SUBJECT: TRANSMITTAL OF BRIEFING CHARTS TO THE ADVISORY COMMITTEE
ON NUCLEAR WASTE (ACNW) FOR THE DECEMBER 1991 BRIEFING

**STAFF TECHNICAL POSITION ON INVESTIGATIONS TO IDENTIFY
FAULT DISPLACEMENT AND SEISMIC HAZARDS AT A GEOLOGIC
REPOSITORY**

**RESPONSES TO COMMENTS ON THE STAFF TECHNICAL POSITION:
INVESTIGATIONS TO IDENTIFY FAULT DISPLACEMENT AND
SEISMIC HAZARDS AT A GEOLOGIC REPOSITORY**

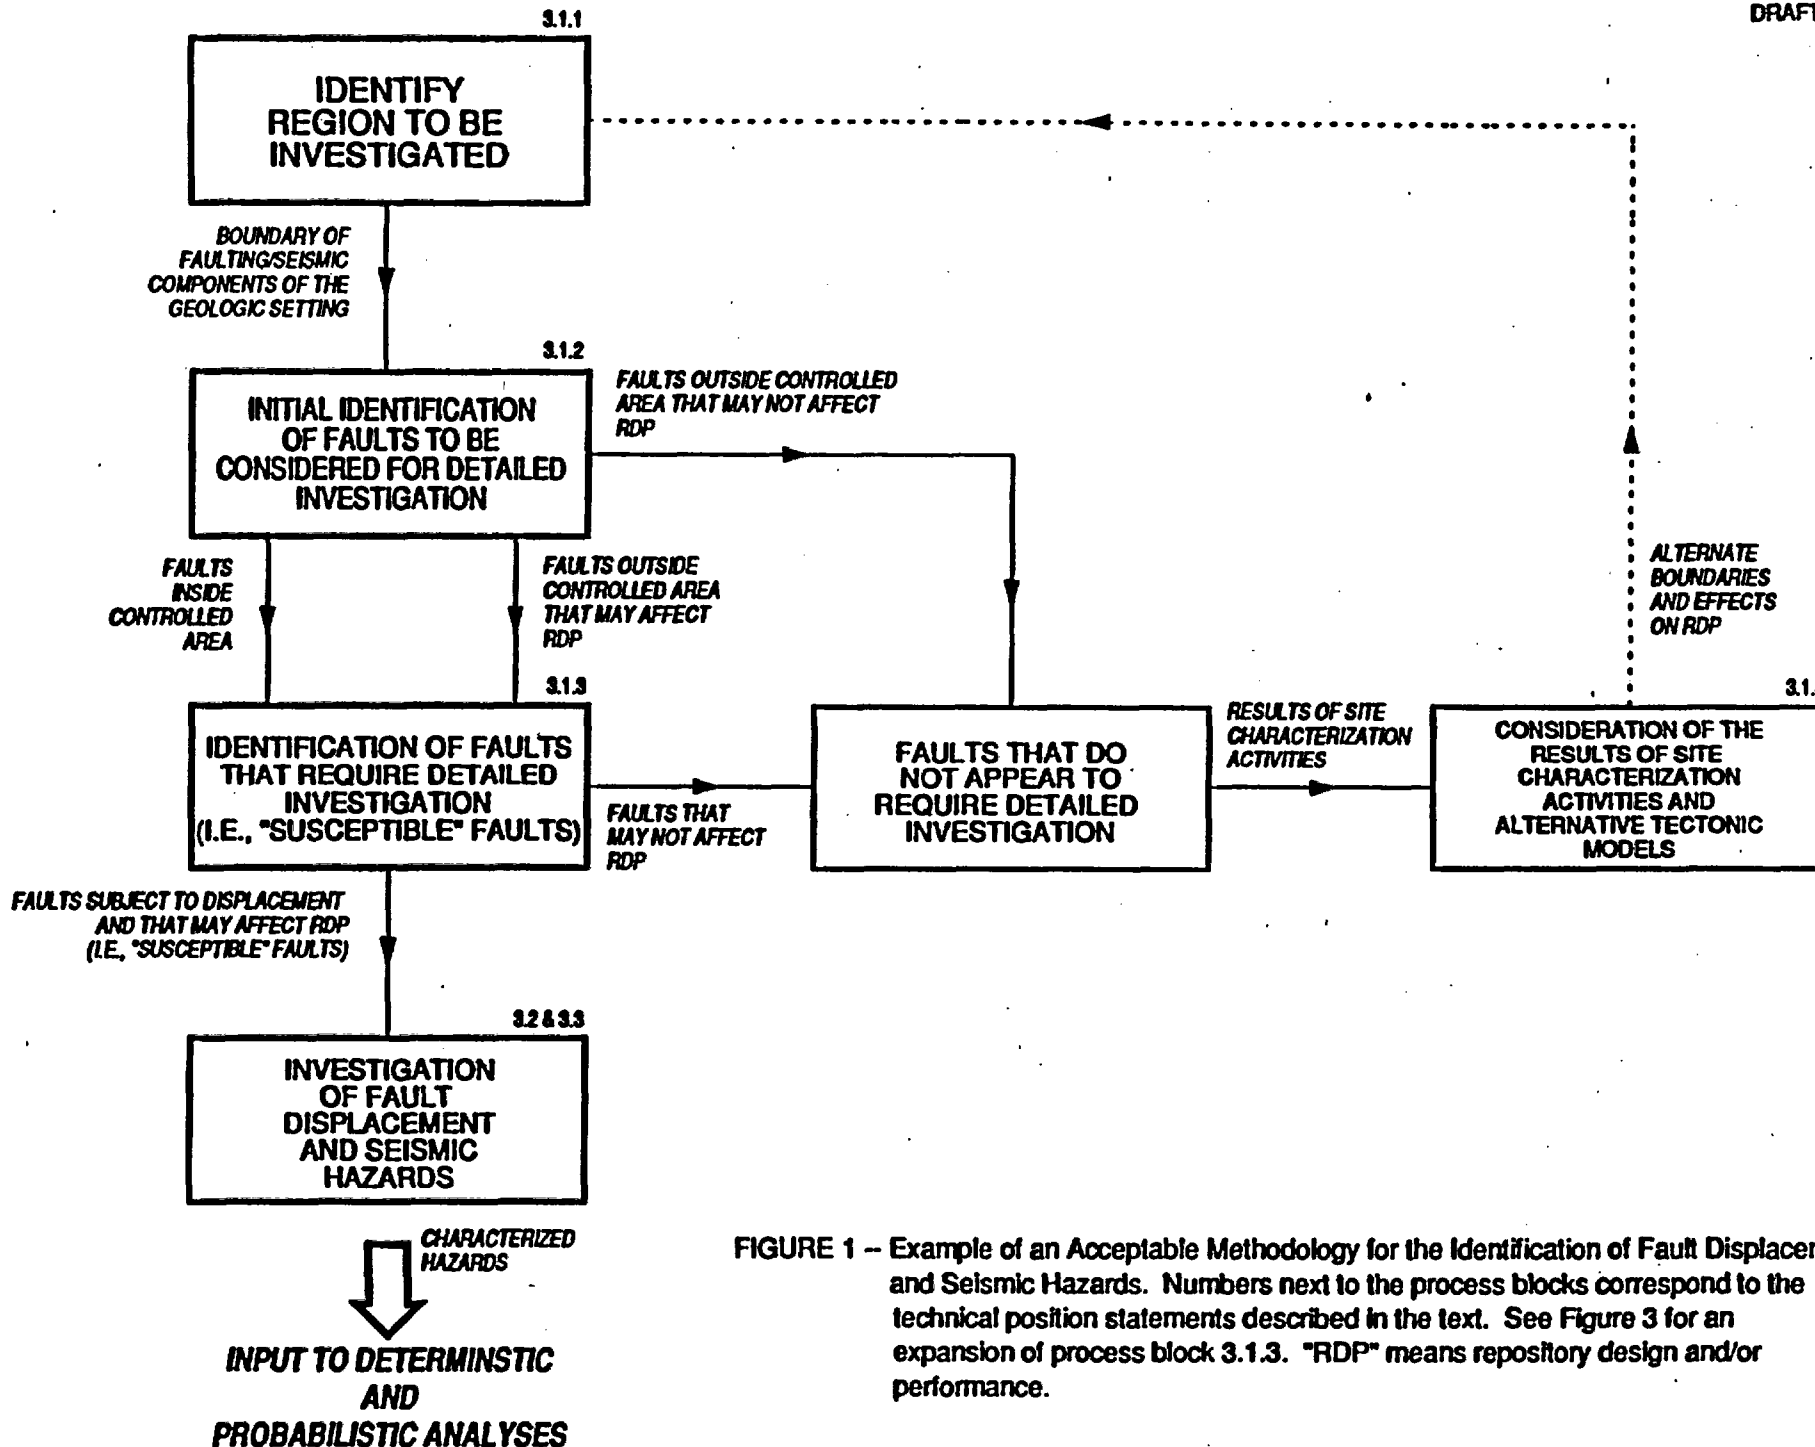
- Disagree with the concept that probabilistic techniques be avoided because they are not sufficiently conservative to identify faults requiring detailed investigation (App. E, AEG comment #4).
- A responsible method of assessment can be accomplished with a probabilistic technique. Empirical relationships form the foundation for a probabilistic approach (App. E, AEG comments #6 and #7).
- The STP rejects, without technical basis, the use of probabilistic techniques in determining which faults require detailed investigation. Appendix A to 10 CFR 100 is likely to endorse a combination of probabilistic and deterministic approaches (App. E, DOE comment #3).
- Combining probabilistic and deterministic approaches to earthquake hazard and design-basis development is most appropriate and is representative of the current state of art (App. E, DOE comment #3).

- **Recognition that the process to identify fault displacement and seismic hazards may not be entirely "deterministic"**
- **Narrows criteria used to identify faults that require detailed investigation**
- **Permit the removal of criteria from further consideration for the identification of faults subject to displacement if data are inconclusive (with appropriate documentation)**
- **Explicitly identify the staff consideration that it is better to err on the side of identifying some matters that may ultimately be found to be unimportant**
- **Recognize that collection of seismicity data below that which would produce less than 0.1g at the site may be important for the postclosure period of performance**
- **Added an appendix that more explicitly states why Appendix A of 10 CFR 100 is not applicable to a high-level waste repository.**

- **Benefits from past regulatory experience in using explicit criteria for identifying fault and seismic hazards**
- **Outline data necessary to fulfill requirements of 10 CFR 60**
- **Use deterministic criteria to determine which faults require detailed investigation**
- **Permit the removal of criteria from further consideration for the identification of faults subject to displacement if data are inconclusive (with appropriate documentation)**
- **Identify the entire Quaternary record as the period of geologic time that should be considered**
- **Allow for reconsideration of faults eliminated from further consideration if assumptions change.**
- **Recognizes the need to perform iterative assessments of performance and that additional investigations to those noted in the STP may be identified by these assessments.**

FIGURE 3 -- Staff Technical Position 3.1.3: Detail to the "Approach to the Identification of Faults that Require Detailed Investigation (I.e., "susceptible" faults)." Refer to the text for the discussion of this two-step process. Also see Figure 1. "RDP" means repository design and/or performance.

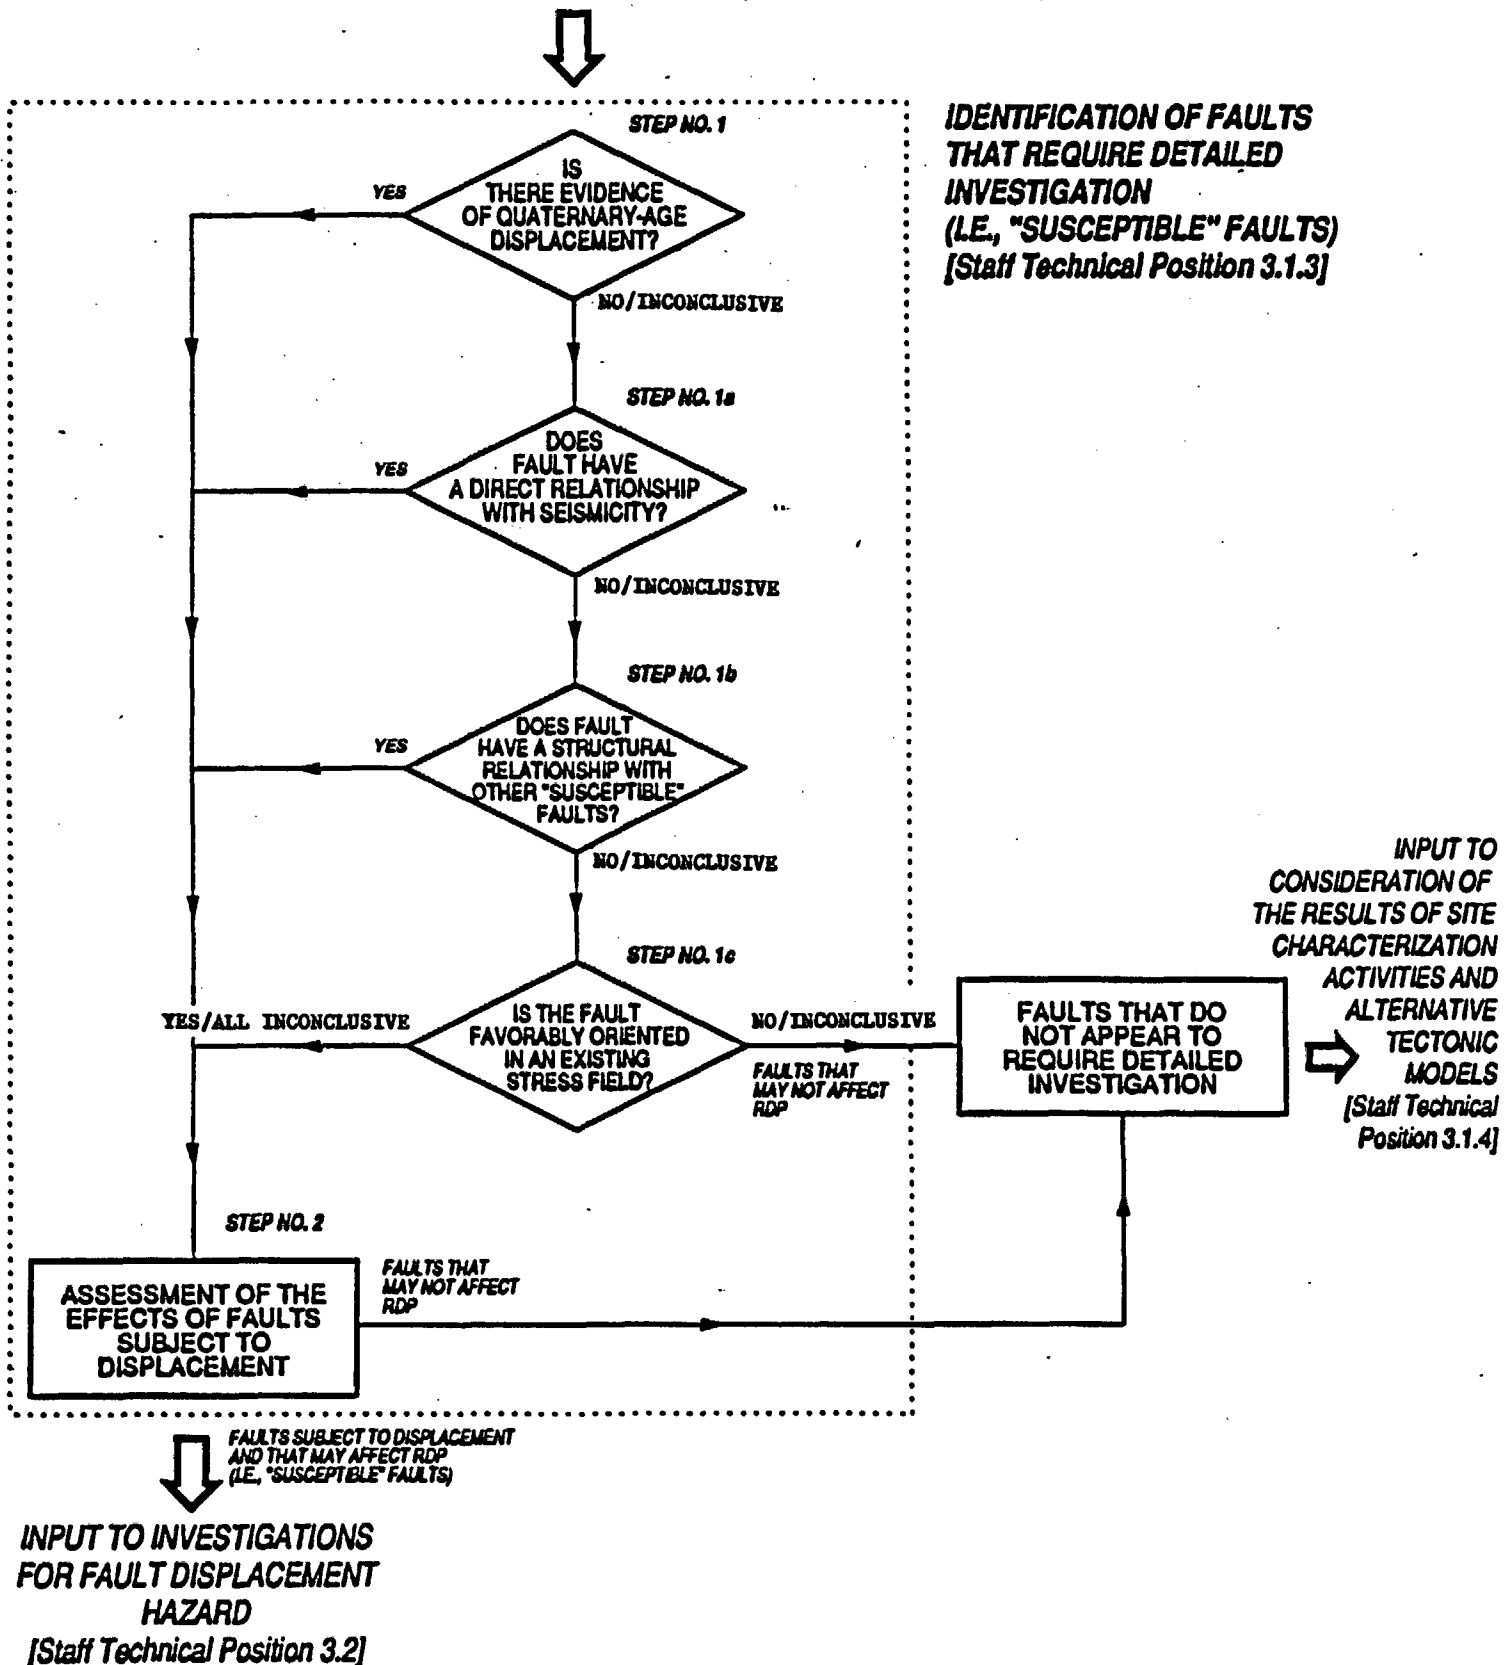
- Uncomfortable with the name "susceptible" fault. Concerned that unique terminology may be developed for different applications (i.e., nuclear power stations vs. radioactive waste disposal) (App. E, AEG comment #2).
- DOE believes the technical basis for the STP has not been demonstrated. STP appears to suggest that an unacceptable risk would exist if a fault with certain characteristics was not investigated in detail. No technical basis for the approach has been provided (App. E, DOE comment #2).
- The concept of "susceptible" faults has not been reviewed by the geologic community (App. E, DOE comment #6, NEV comment #3).
- The use of the term "susceptible fault" is vague, prejudicial, and misleading (App. E, EEI/UWASTE).

A Susceptible fault is a fault that:

- 1) is subject to displacement; and**
- 2) affects the design or performance of structures, systems, and components important to safety, containment, or waste isolation; and/or**
- 3) will provide data for significant input to models used in assessments of design or performance of structures, systems, and components important to safety, containment, or waste isolation**
